Subject: Braidwood Station Units 1 and 2
FSAR Change Concerning Project
Start-up Organization
NRC Docket Nos. 50-456/457

Enclosed for your advance information are changes to the Byron/Braidwood FSAR that fully explain our new Braidwood Project Start-up Organization. Our Byron/Braidwood FSAR Chapters 13 and 14 will be amended to include this information in the next Amendment.

Figure 13.1-3

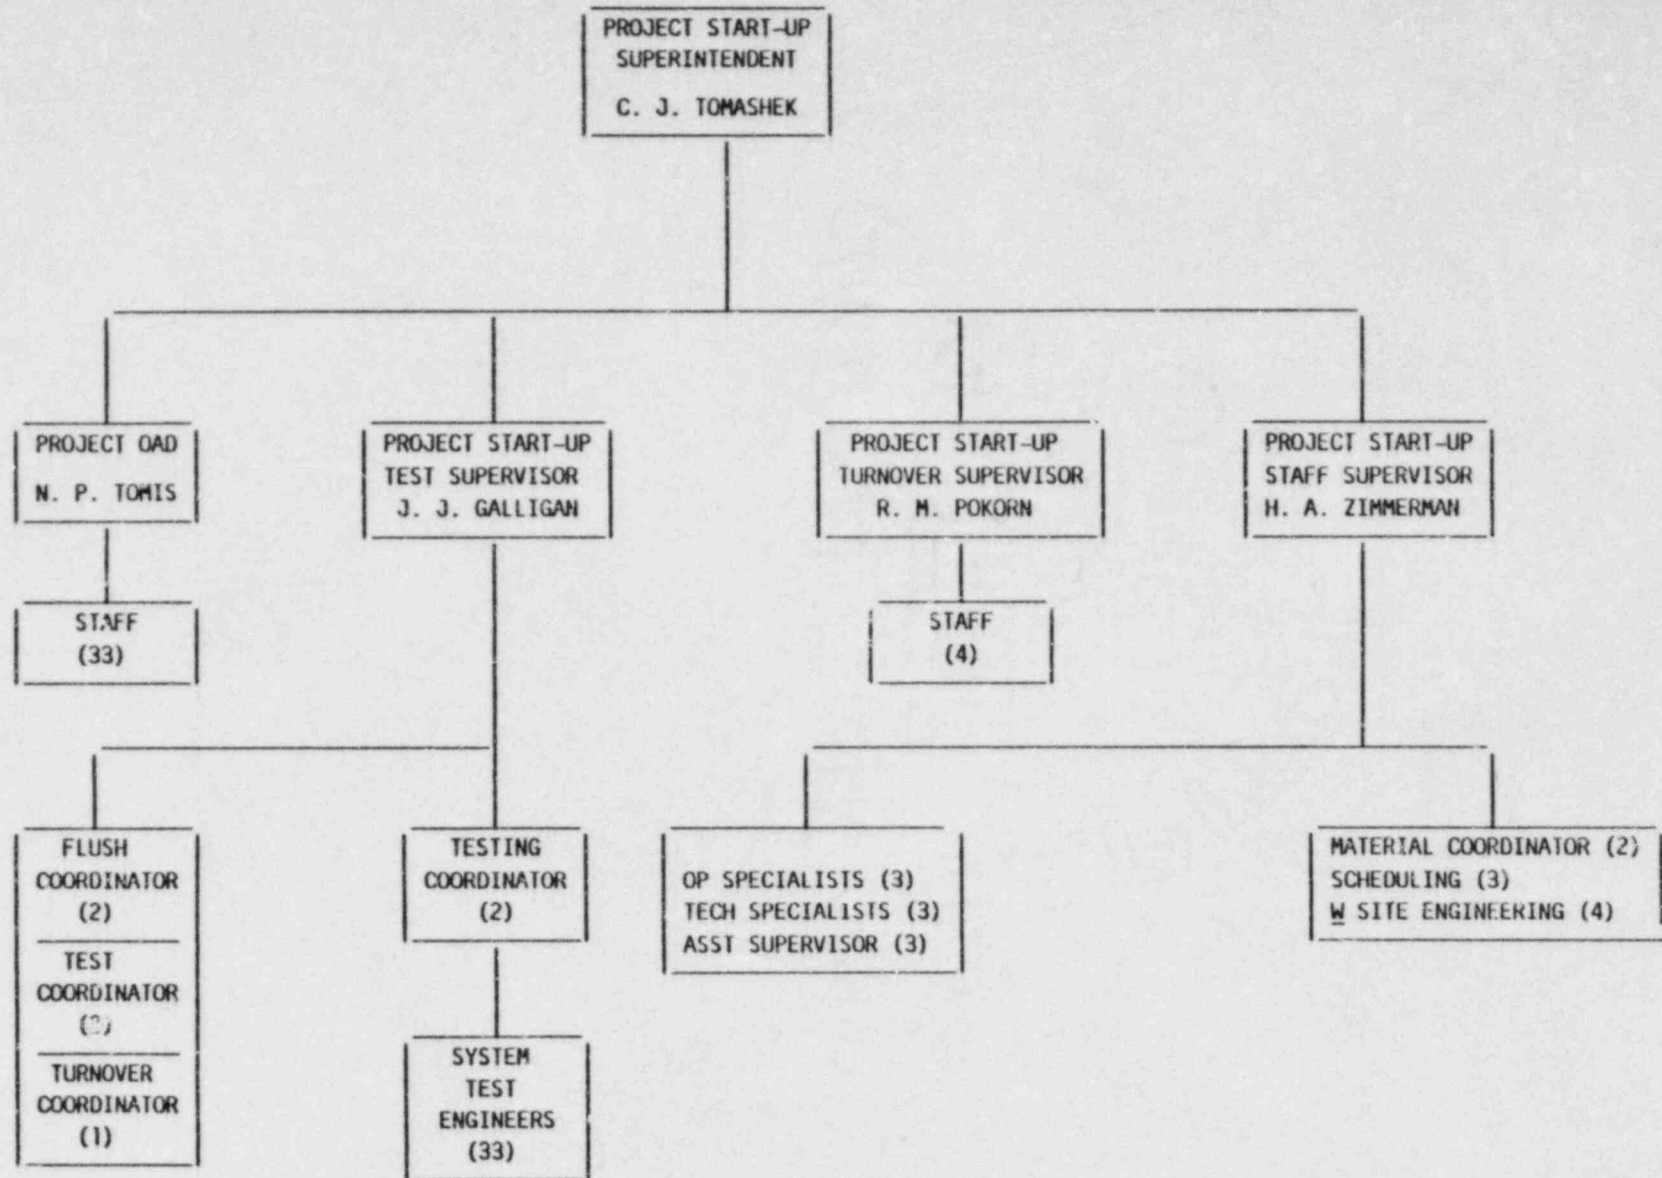
An organization chart of the Project Start-up Organization is provided in Figure 13.1-3.

This chart indicates the title of each position and the anticipated number of persons assigned to common or duplicate positions at the time of peak activity.
